Access Compliance Report

Public Rights-of-Way

(Curb Ramps)

Intersection ID: 10031974	Main Street: MONROE_RD	Cross Street: N/A	Location: NE
ADA ID: DD2DFDEB451A	Ramp Type: Para	Initial Pass/Fail: Fail	Overall Compliance: No
		Severity Score: 12.5

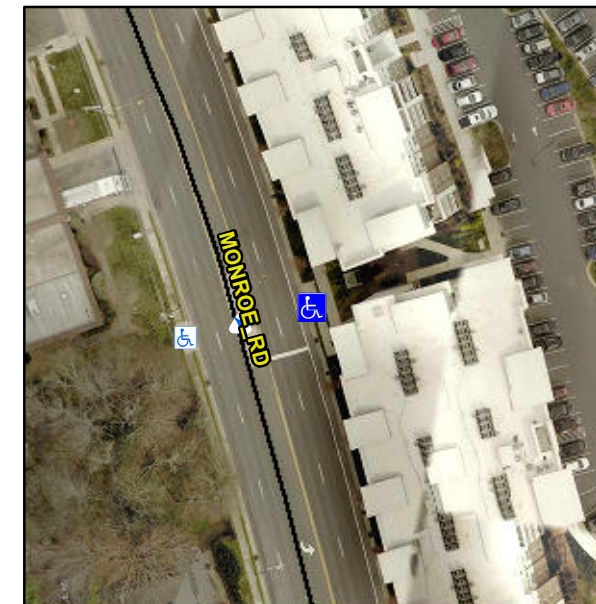
Compliance	Description	Data	Compliance	Description	Data
N/A	Ramp Length LT (in)	73.0	N/A	Ramp Length RT (in)	302.0
Yes	Ramp Width LT (in)	71.0	Yes	Ramp Width RT (in)	70.0
No	Ramp Slope LT (%)	8.5	Yes	Ramp Slope RT (%)	5.8
Yes	Ramp XSlope LT (%)	0.5	Yes	Ramp XSlope RT (%)	1.2
N/A	Landing Length (in)	N/A	N/A	DWS Provided?	N/A
N/A	Landing Width (in)	N/A	N/A	DWS Contrast?	N/A
N/A	Landing Slope (%)	N/A	N/A	DWS Length (in)	N/A
N/A	Landing X Slope (%)	N/A	N/A	DWS Full Width?	N/A
N/A	Landing Curb? (Y/N)	N/A	N/A	DWS Offset (in)	N/A
N/A	Shared Landing?	N/A			
N/A	Gutter Ponding?	N/A	N/A	Gutter Slope (%)	N/A
N/A	Gutter Lip Ht (in)	N/A	N/A	Gutter X Slope (%)	N/A
N/A	Painted X Walk1?	No	N/A	Painted X Walk2?	N/A
	X Walk 1 Direction	To SW		X Walk 2 Direction	N/A
N/A	X Walk 1 Width (in)	N/A	N/A	X Walk 2 Width (in)	N/A
	X Walk 1 Slope (%)	4.3		X Walk 2 Slope (%)	N/A
	X Walk 1 X Slope (%)	1.4		X Walk 2 X Slope (%)	N/A
N/A	Ramp inside XWalk1?	N/A	N/A	Ramp inside XWalk2?	N/A

Remove & Replace Entire Ramp.
